**HAM CR 251 0.11
 BLUE ASH RD PH 2**

CITY OF DEER PARK
 HAMILTON COUNTY

REVIEW COMPLETE

STAGE 1 SUBMITTAL - 2/14/2025

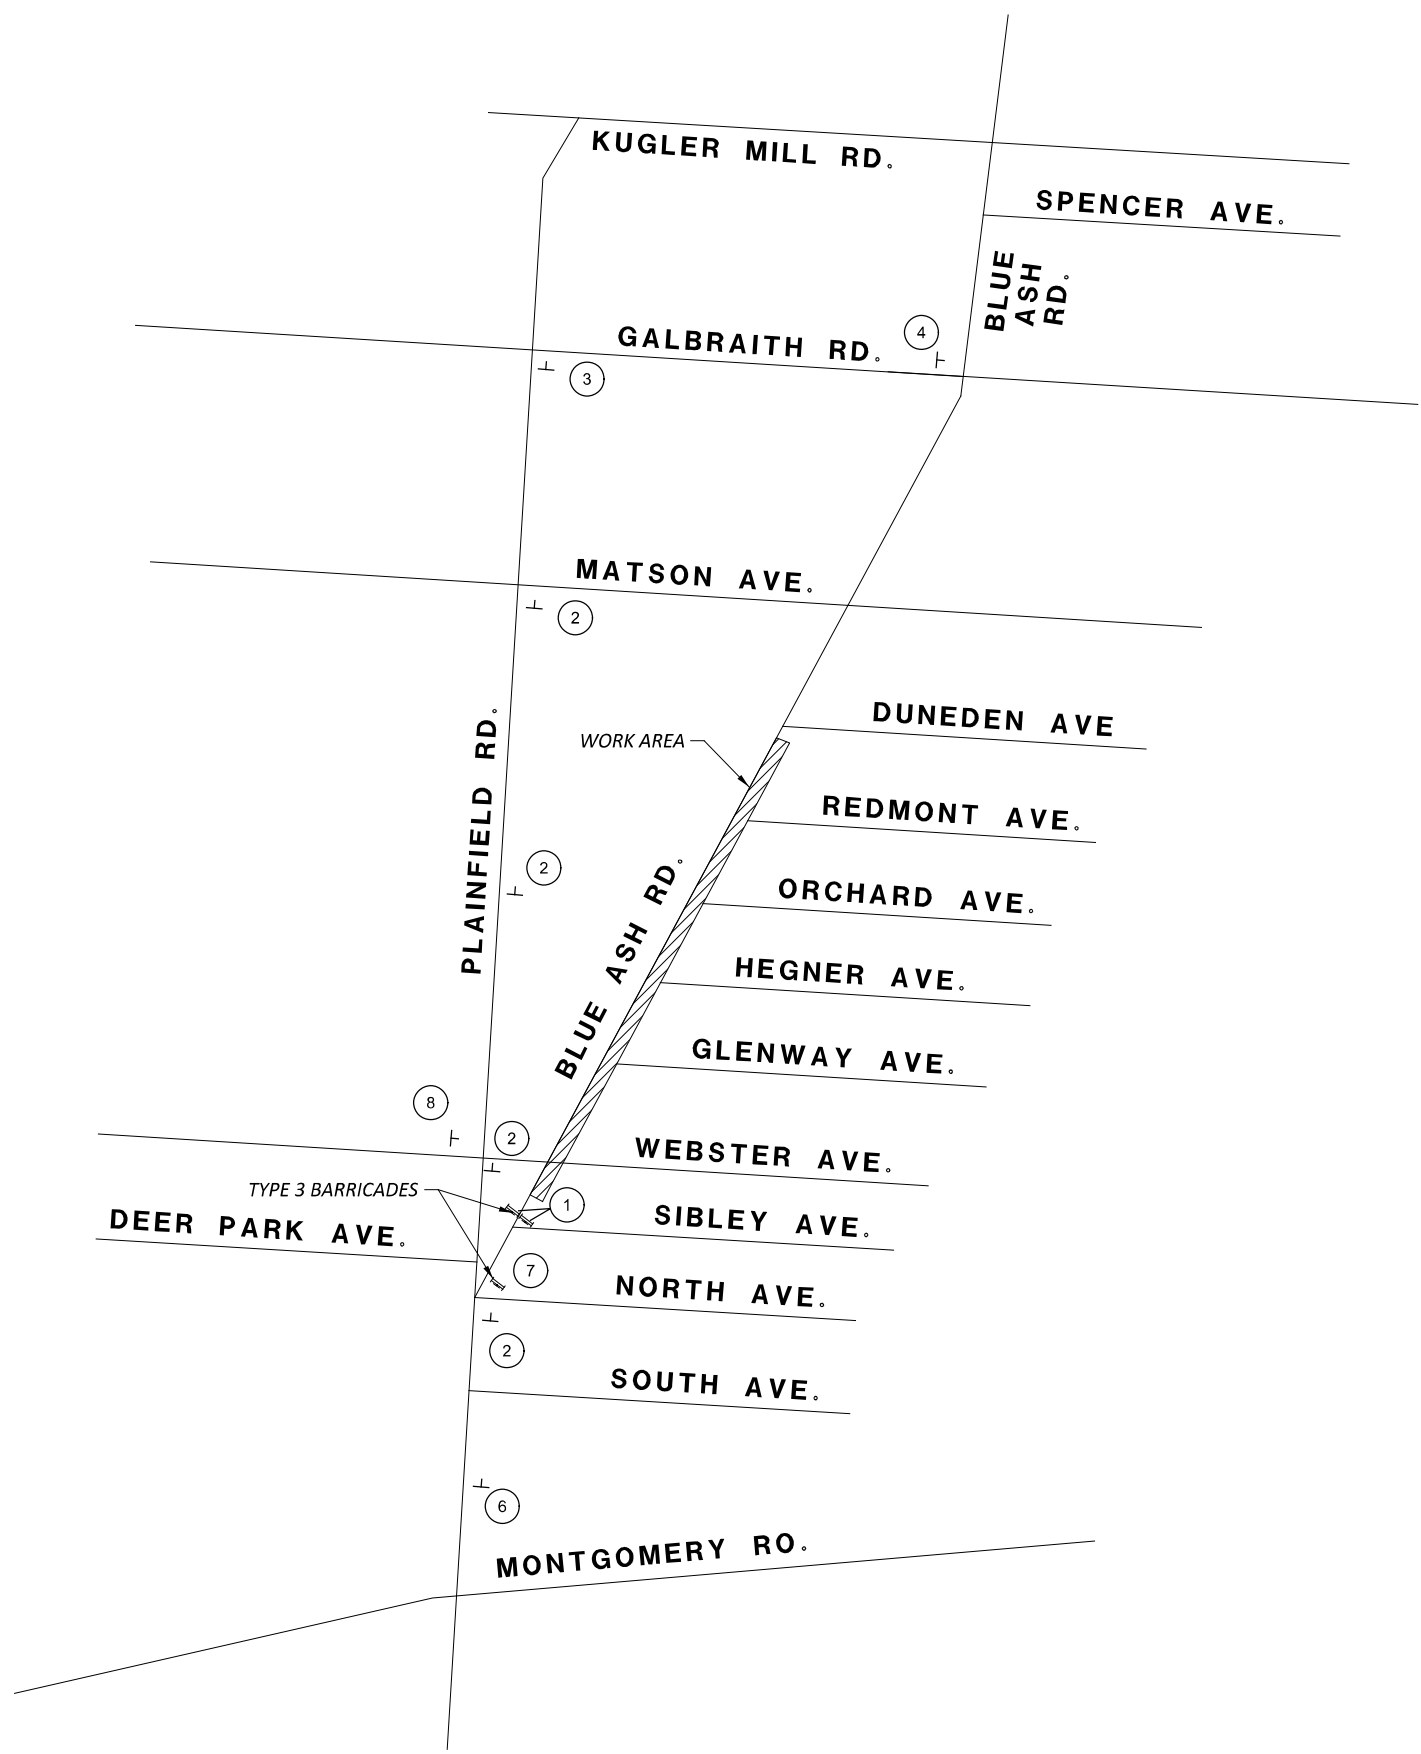
This sign should be mounted below barricades, not below a W20-3. ✓

Is PCB proposed on both sides of Blue Ash Rd? Typical comment

Show WZIA. Typical comment. ✓

PB is only one side. Updated linestyle and legend for clarity.

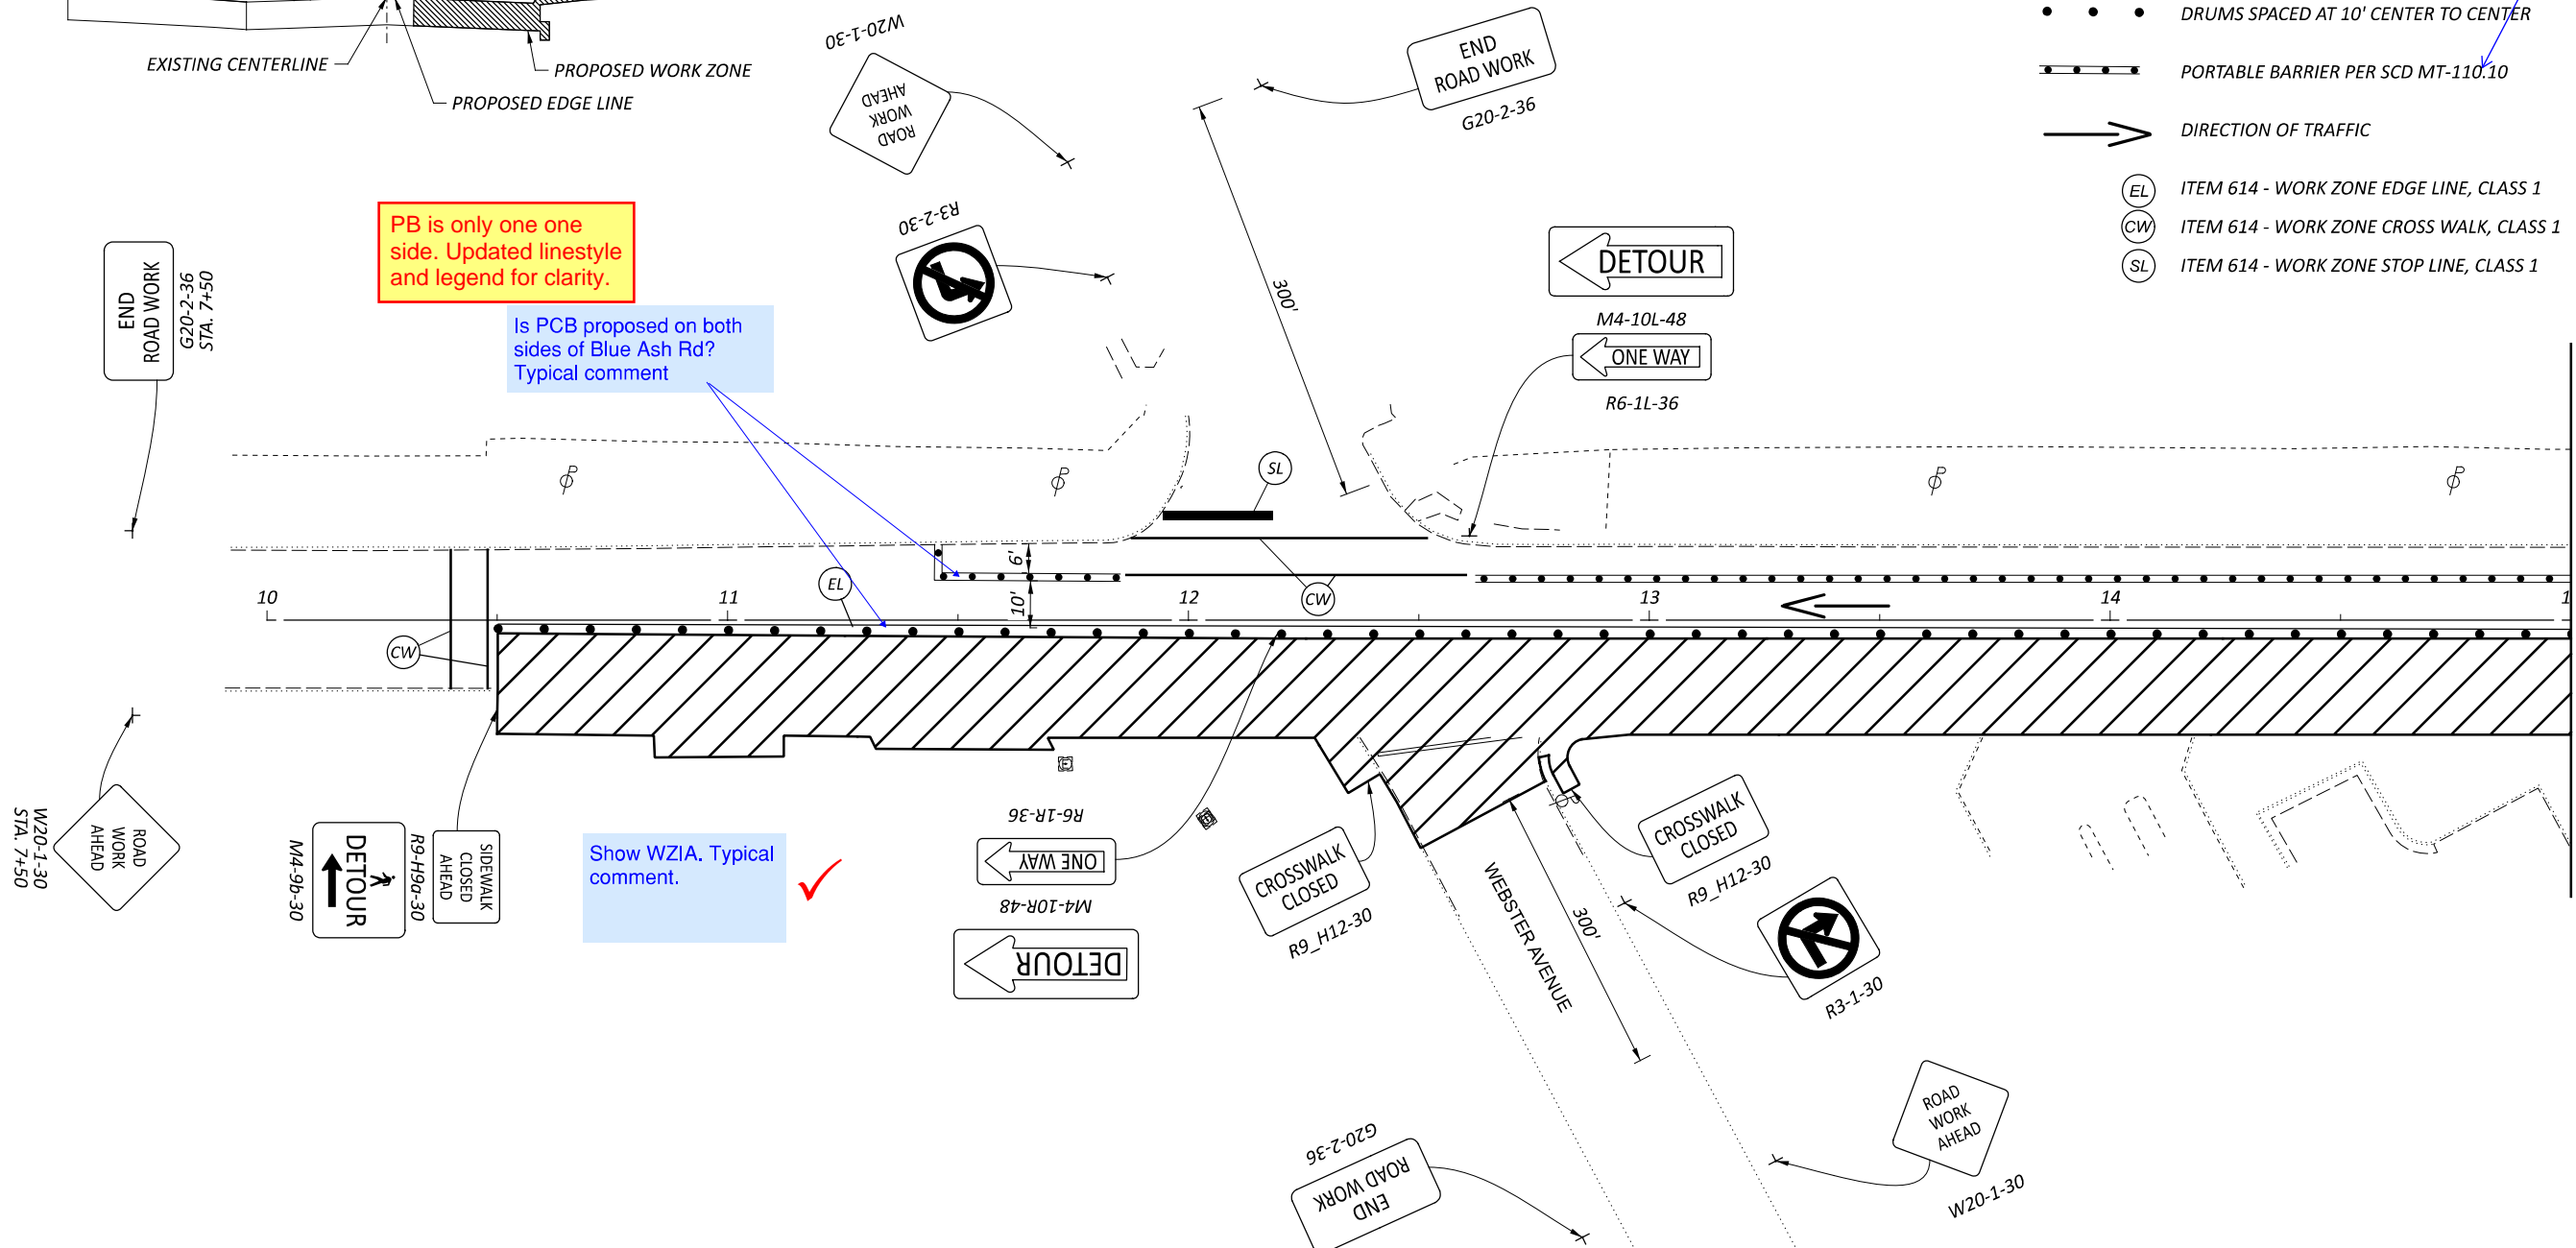
Revise SCD - typical comment.

Barriers to be used for pedestrians per noted SCD.

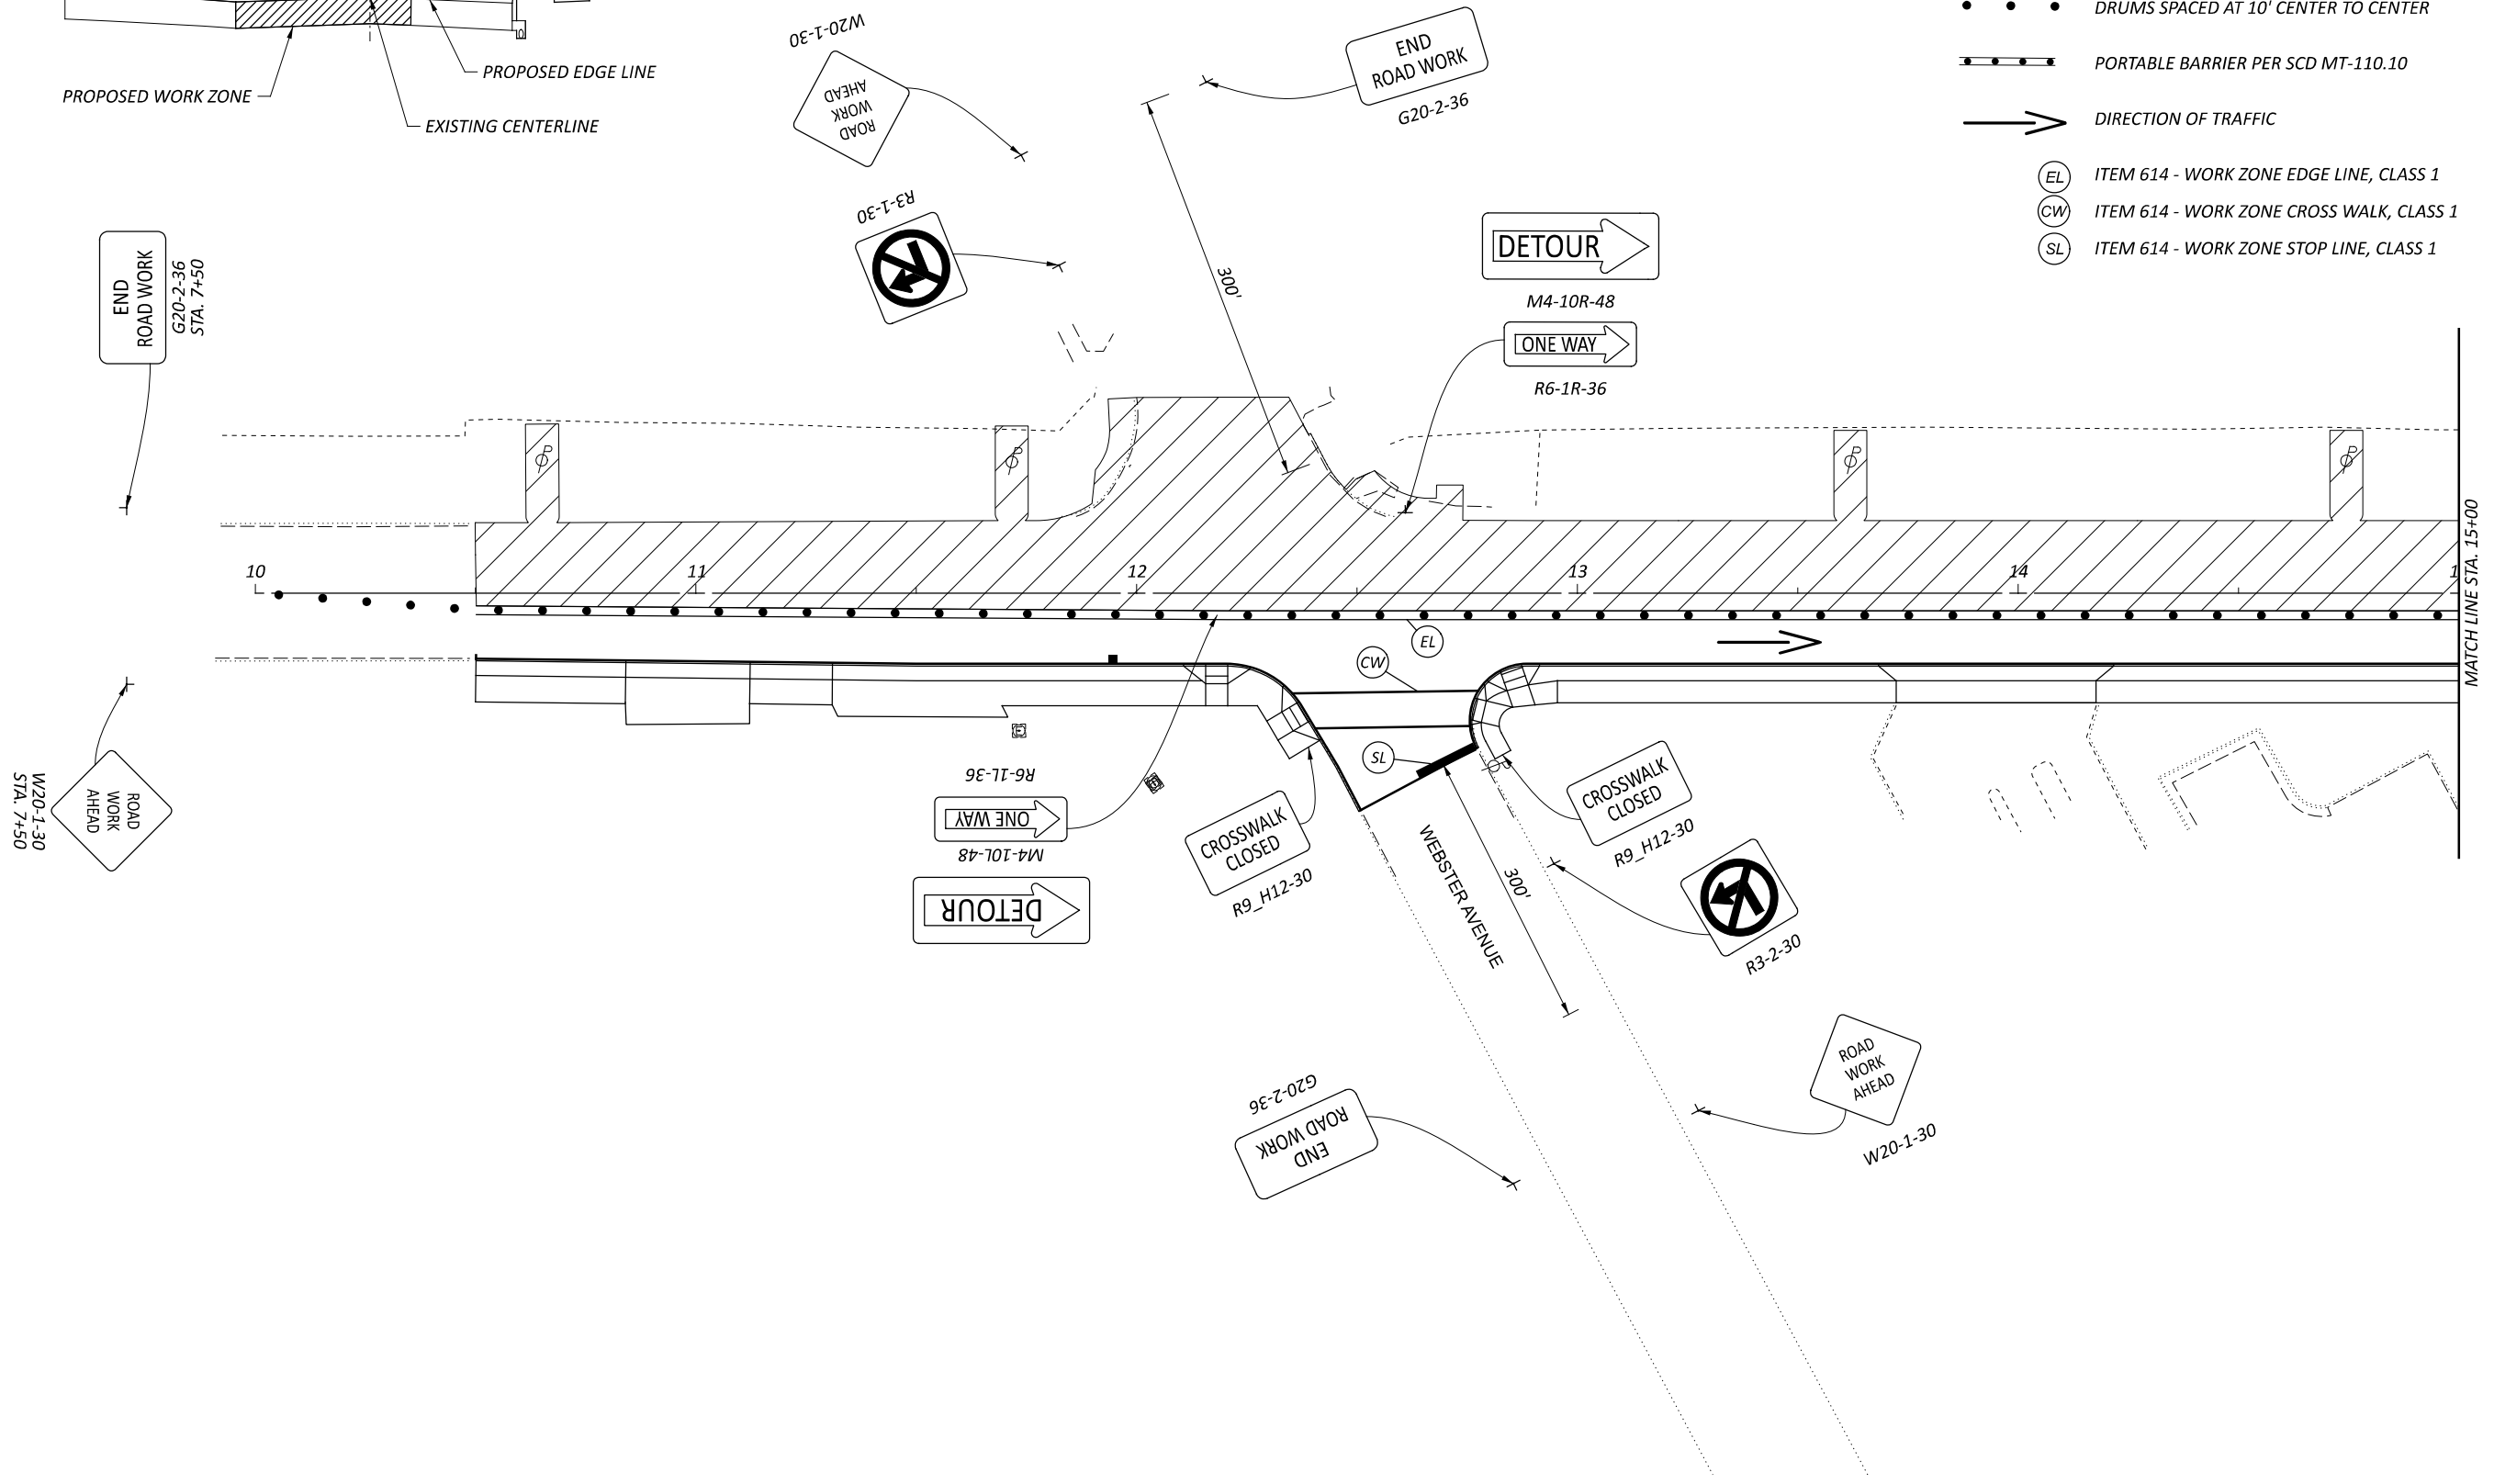
This sign should be mounted below barricades, not below a W20-3. ✓
